SUBJECT: PRELIMINARY SITE PLAN APPROVAL (JPLN2023-0031) –. Proposed Wattles Square Apartments, South side of Wattles and east of John R (PIN 88-20-24-100-039), Section 24, Zoned NN (Neighborhood Node “F”) Zoning District.

Preliminary Site Plan For City of Troy, Michigan

Applicant:	Atto Construction
Project Name:	Wattles Square Apartment
Plan Date:	December 5, 2023
Location:	South side of Wattles, east of John R.
Zoning:	NN, Neighborhood Node, Site Type B
Action Requested:	Preliminary Site Plan Approval

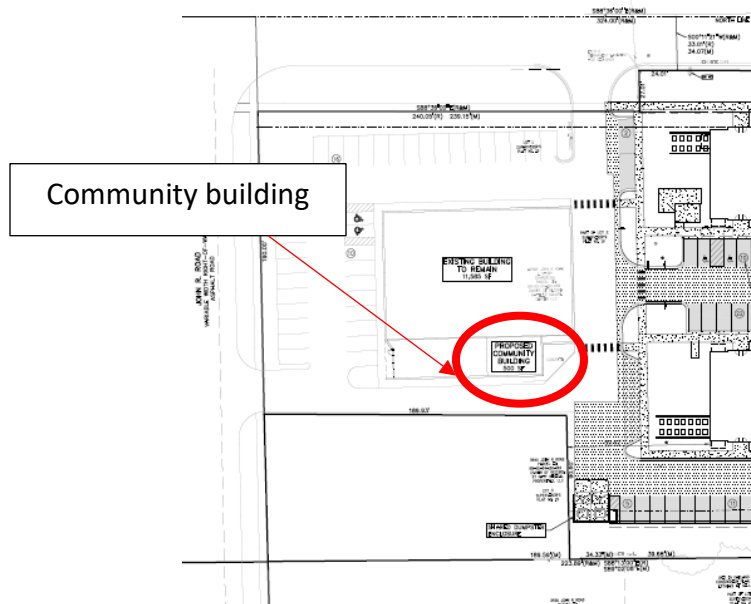
The applicant proposes to convert a 500 sq/ft section of the existing RiteAid building into a community building for tenants. This separate 500 sq/ft area is located in the southwest corner of the RiteAid building and is currently vacant. Floor plans provided by the applicant indicate that

the community building includes one (1) large, open-concept room and one (1) restroom. The large community room includes: a living room area with a 60-inch flat screen and sitting furniture; a dining area with a table, six (6) chairs, and counter space with a sink and 24-inch mini-fridge; and a workout area with four (4) pieces of equipment and two (2) ADA compliant drinking fountains.

Additionally, colored renderings provided by the applicant show the inclusion of a small patio near the community room entrance. Renderings indicate enough patio space for two (2) small tables, one (1) box plant, and a small group of people. A transformer with a 64-inch screening wall is also shown on the patio.

Items to be Addressed: Planning Commission evaluation of community building compliance with the intent and design standards of Neighborhood Node District.

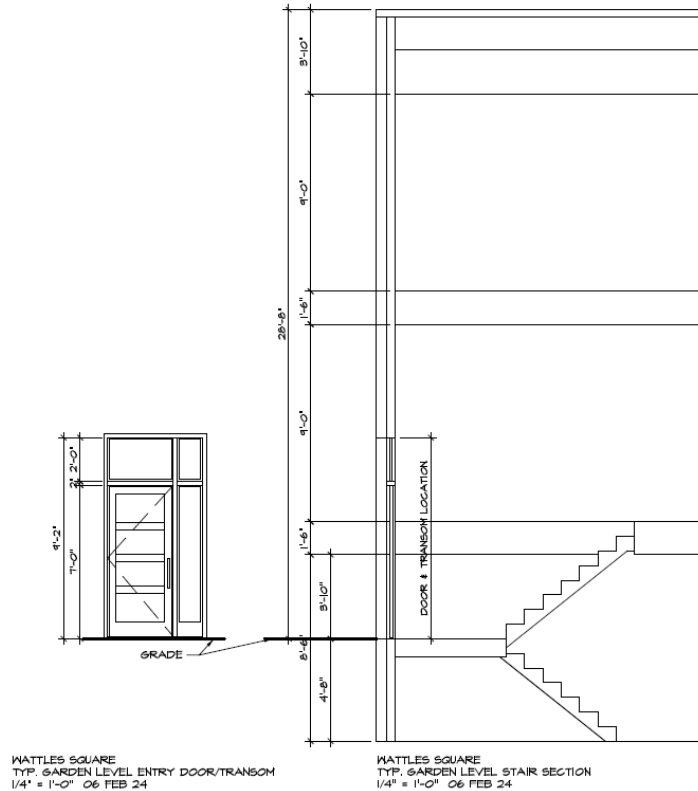
The applicant states that the ground floor is 4'-8" underground and 3'-10" is above grade, thus they conclude that more than " fifty (50) percent by cubic content, is below the height level of the adjoining ground", and thus does not constitute a story. See the cross section below.

The applicant and staff have gone back and forth on the issue of height and stories. While the applicant may meet the letter of the Zoning Ordinance by manipulating the grade, we have raised a number of concerns regarding the number of stories:

The Planning Commission should consider items of concern raised by use of “garden level” apartments. We strongly encourage the applicant to redesign the buildings to provide a true two or two-half story building.

Items to be Addressed: 1). Planning Commission evaluation of ‘items of concern.’ 2). Applicant to clarify intentions with increasing building height.

Building Height in Colored Renderings, Received on March 18, 2024.

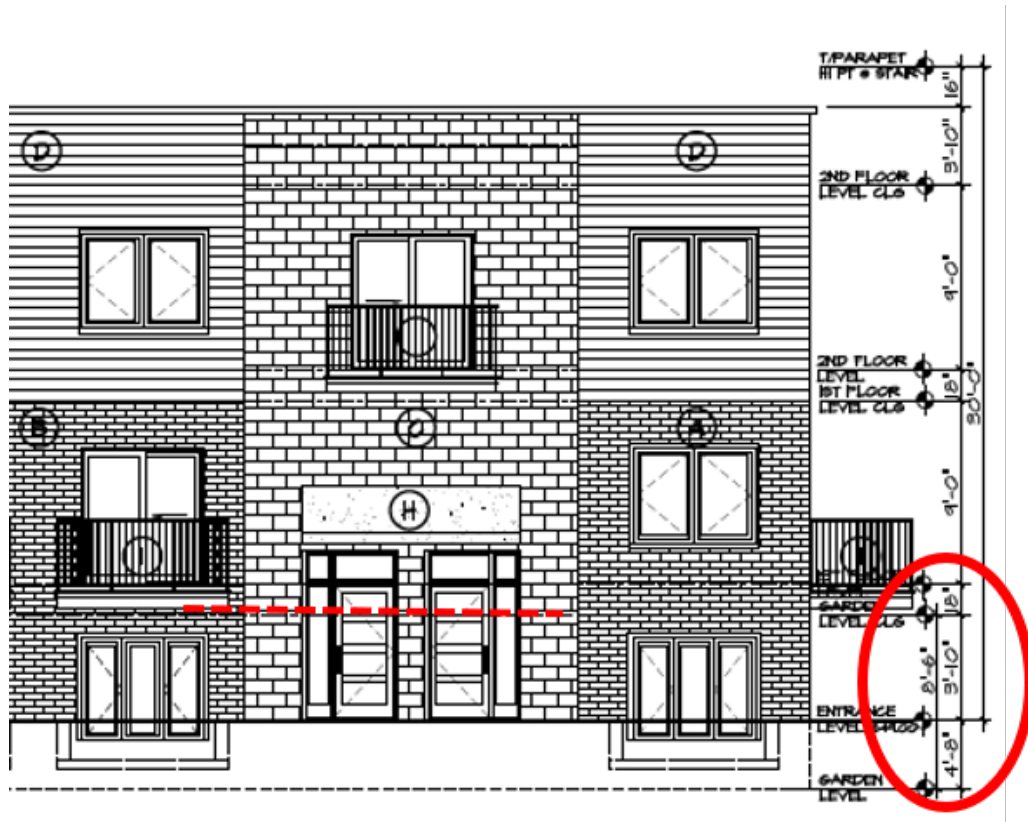
Site plans provided by the applicant present a flat-roof design in which elevations are no greater than 30 feet. However, colored renderings received by the applicant on March 18, 2024, include modifications to the roof type and height. In the renderings, the applicant shows the previously proposed flat roof with a 30-foot overall height as the “original design.” With this, a new “sloping roof design” is shown, in which the average building height is 30 feet, and the overall height is 34 feet-10 inches.

It is not clear what the intention is of showing the sloping roof design.
